Addendum 77 – UN Regulation No. 78

Revision 2 - Amendment 2

05 series of amendments – Date of entry into force: 3 January 2021

Uniform provisions concerning the approval of vehicles of categories L1, L2, L3, L4 and L5 with regard to braking

Model B

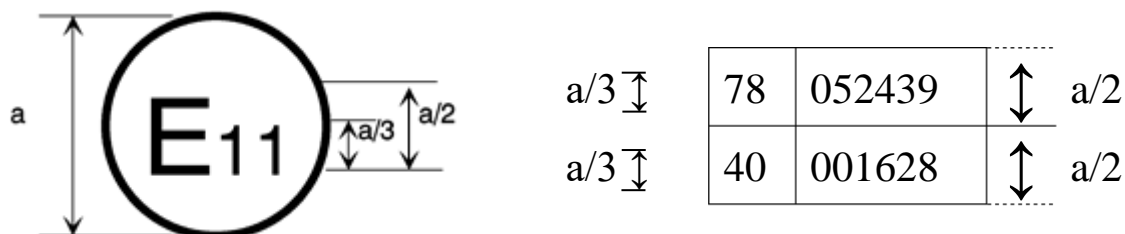
Annex 2, amend to read:

The above approval mark affixed to a vehicle shows that the vehicle type concerned has been approved in the United Kingdom (E 11) pursuant to UN Regulations Nos. 78 and 40. The first two digits of the approval numbers indicate that, at the dates when the respective approvals were granted, UN Regulation No. 78 included the 05 series of amendments but UN Regulation No. 40 was still in its original form.
